29th Floor - M-529.00: Change Areas, Before and After

Before = Addendum 1 (installed) | After = Bulletin 3 (rev 4, 08/10/2026) | Overlay: gray = unchanged, red = Addendum 1 only (installed, removed), blue = Bulletin 3 only (new)

Snowflake Fitout - 7 Times Square, Floors 29-31 | COP-SF-05 Bulletin 3 Revision

29-1 North supply main - reroute through existing beam cuts \$15,075

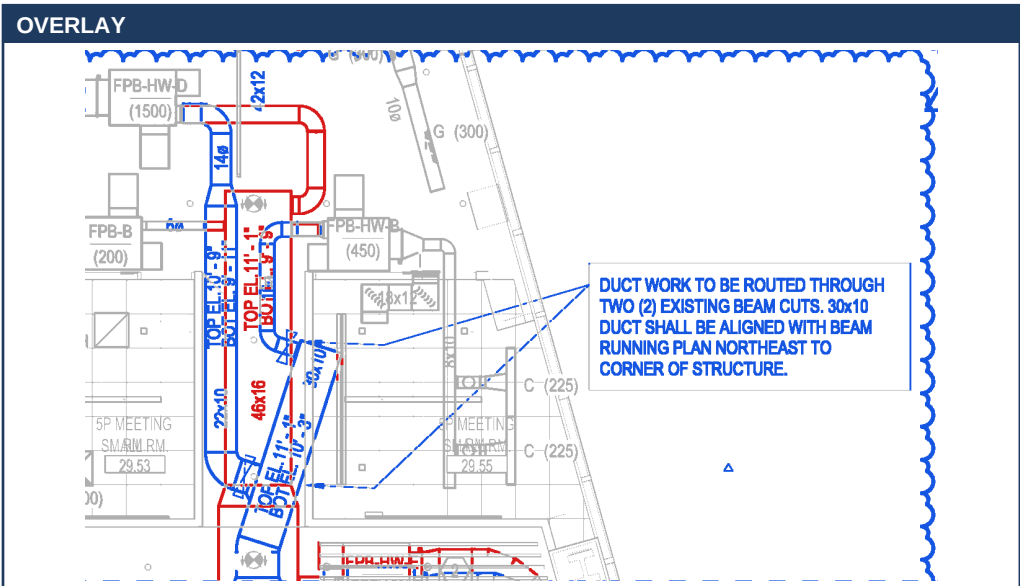
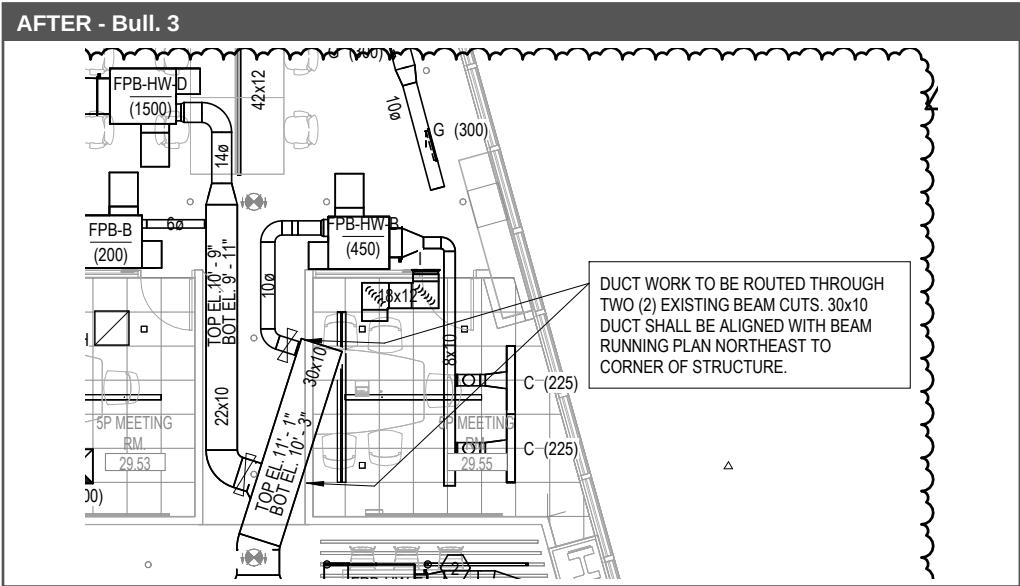
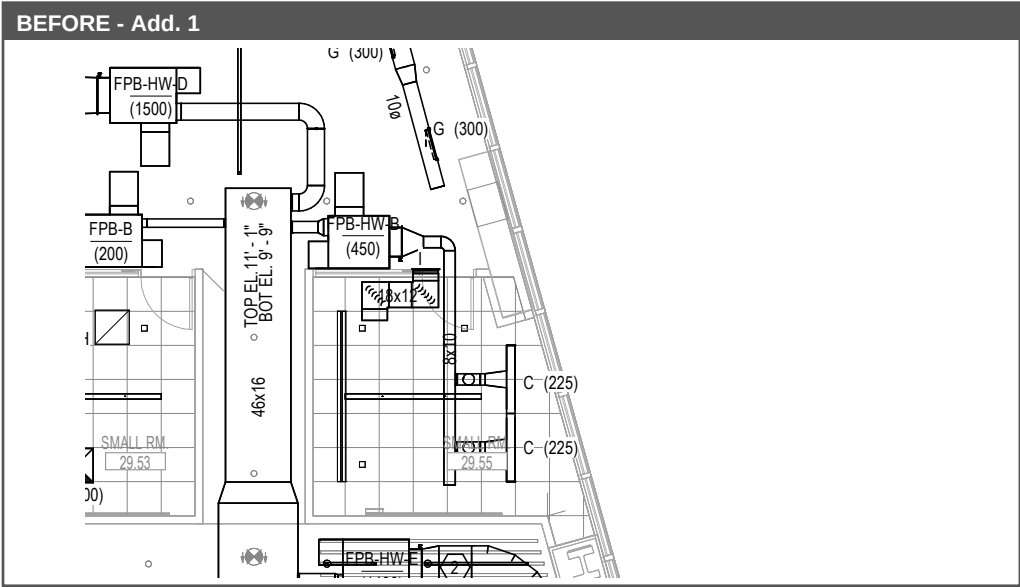
Area	Scope of work	Disconnect / removal	Material	Install labor	Total
29-1	North supply main - reroute through existing beam cuts Before: 46x16 supply main (approx. 20 LF, bottom el. 9'-9") with branch connections to FPB-HW-D (1500), FPB-HW-B (450) and FPB-B (200). After: Main rerouted as 22x10 and 30x10 through (2) existing beam cuts, 30x10 aligned with the beam running plan northeast. New 14ø branch to FPB-HW-D, 10ø to FPB-HW-B and 6ø to FPB-B. Work: Disconnect and remove installed 46x16 section and branch connections. Fabricate and install 22x10 / 30x10 duct and round branches with insulation, reconnect terminal units.	12 MH \$1,500	\$6,075	60 MH \$7,500	\$15,075
29-2	Supply main resized 56x16 to 42x12 Before: 56x16 supply main, approx. 44 LF, top el. 11'-1" / bottom el. 9'-9", Break Rm 29.57 to P.E. After: Main resized to 42x12 on the same route, top el. 11'-1" / bottom el. 10'-1". Work: Disconnect and remove installed 56x16 main. Fabricate and install 42x12 main with insulation, reconnect branch takeoffs (FPB-HW-E, FPB-B (260)).	7 MH \$875	\$3,900	50 MH \$6,250	\$11,025

29-3 FPB-HW-E (1400) relocation and discharge reroute \$2,500

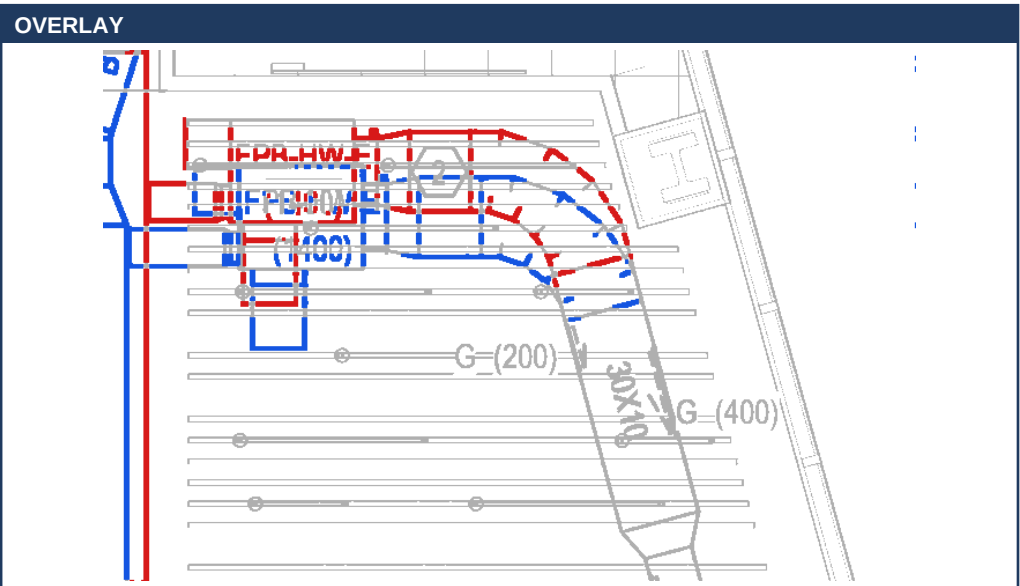
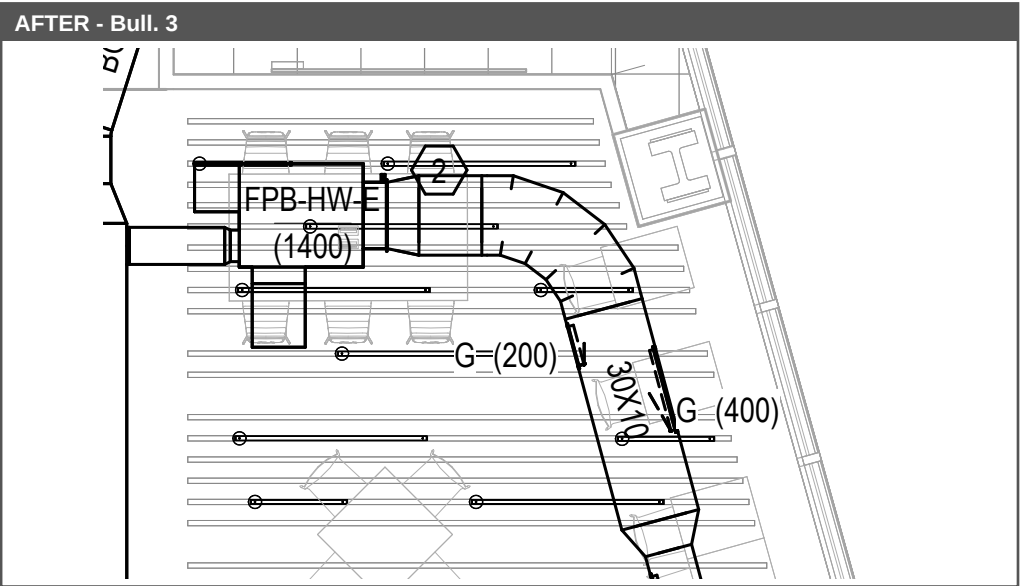
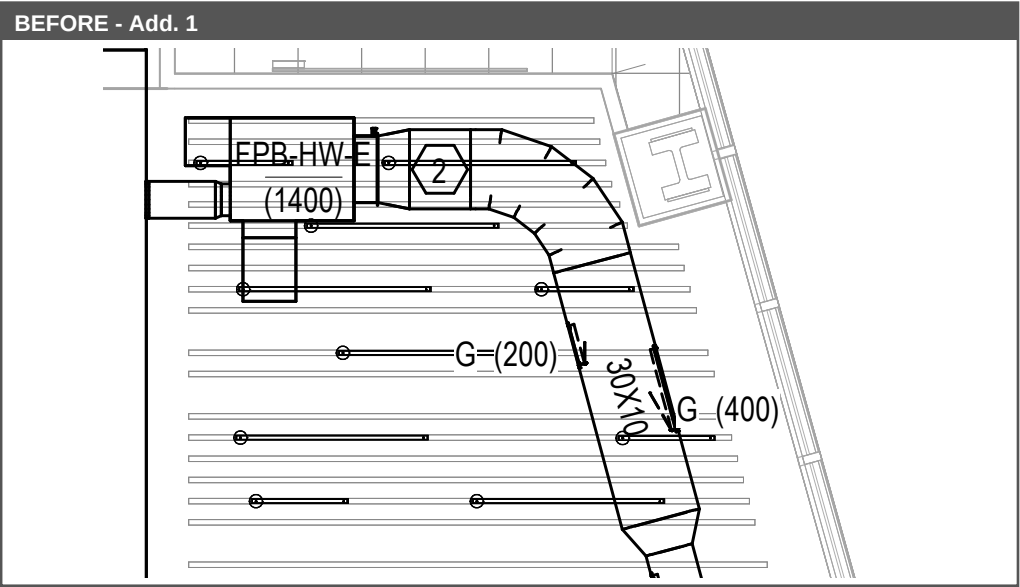
29-3	FPB-HW-E (1400) relocation and discharge reroute Before: FPB-HW-E (1400) with inlet and 30x10 discharge to the G(400) / G(200) linear diffusers along the northeast wall. After: FPB-HW-E relocated; inlet connection and 30x10 discharge elbow rerouted. Work: Disconnect inlet and discharge, relocate and rehang FPB-HW-E, fabricate and install new inlet and 30x10 discharge fittings, reconnect.	2 MH \$250	\$750	12 MH \$1,500	\$2,500
	Shop drawings for revised design				\$1,000
	29th floor total (21 MH disconnect, 122 MH install)	\$2,625	\$10,725	\$15,250	\$29,600

30th Floor - M-530.00: Change Areas, Before and After

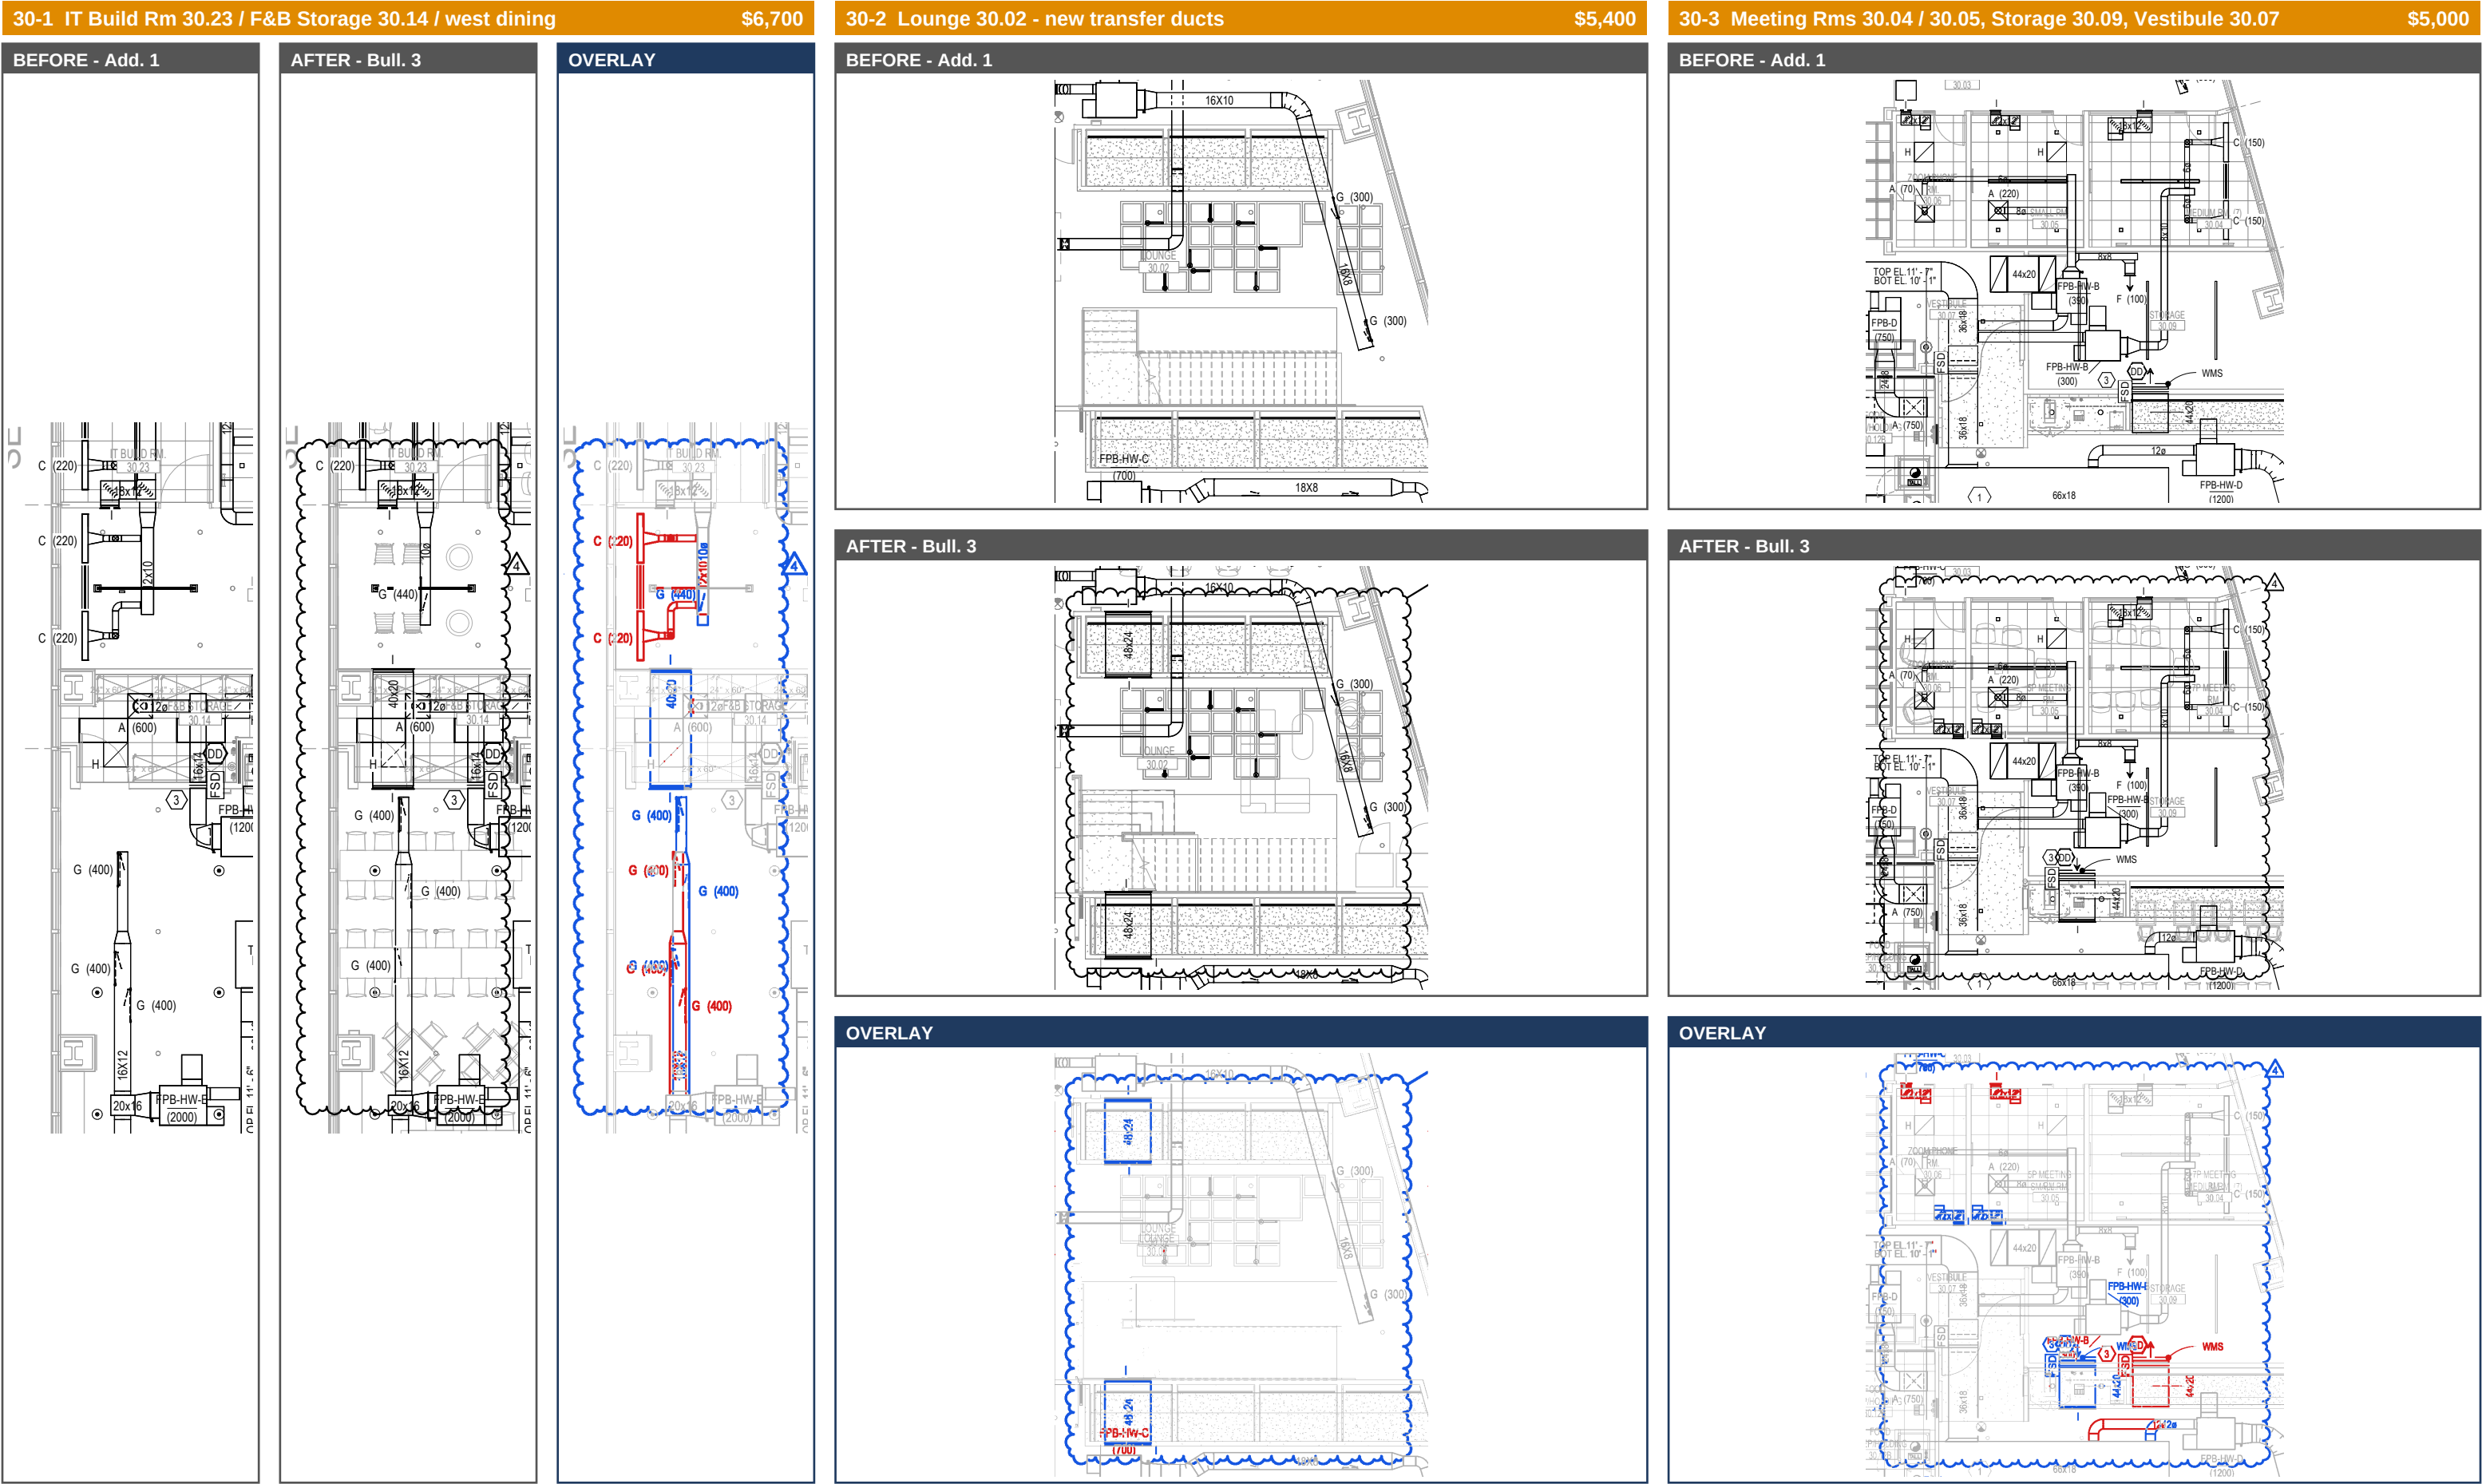
Area	Scope of work	Disconnect / removal	Material	Install labor	Total
30-1	IT Build Rm 30.23 / F&B Storage 30.14 / west dining Before: 12x10 branch with (2) C(220) ceiling diffusers; G(400) linear diffuser run on 16x12 branch. After: 12x10 branch and (2) C(220) deleted, replaced with 10ø branch to (1) new G(440) linear diffuser. New 40x20 transfer duct at F&B Storage 30.14. G(400) linear diffusers relocated along the 16x12 branch. Work: Disconnect and remove 12x10 branch and (2) C(220). Install 10ø branch, 40x20 transfer duct, rework 16x12 branch. F&I G(440).	6 MH \$750	\$2,200	30 MH \$3,750	\$6,700
30-2	Lounge 30.02 - new transfer ducts Before: No transfer ducts at Lounge 30.02 walls. After: (2) new 48x24 transfer ducts. Work: Fabricate and install (2) 48x24 lined transfer ducts.	-	\$2,150	26 MH \$3,250	\$5,400
30-3	Meeting Rms 30.04 / 30.05, Storage 30.09, Vestibule 30.07 Before: 44x20 transfer duct; (2) 12x12 grilles; 12ø branch to FPB-HW-D (1200). After: (2) 12x12 grilles relocated to 5P / 7P Meeting; 12ø branch rerouted. Work: Disconnect and remove affected duct, fittings and grilles. Install 44x20 transfer duct and 12ø branch at new locations.	16 MH \$2,000	-	24 MH \$3,000	\$5,000

Shop drawings for revised design				\$1,000
	30th floor total (22 MH disconnect, 80 MH install)	\$2,750	\$4,350	\$10,000	\$18,100
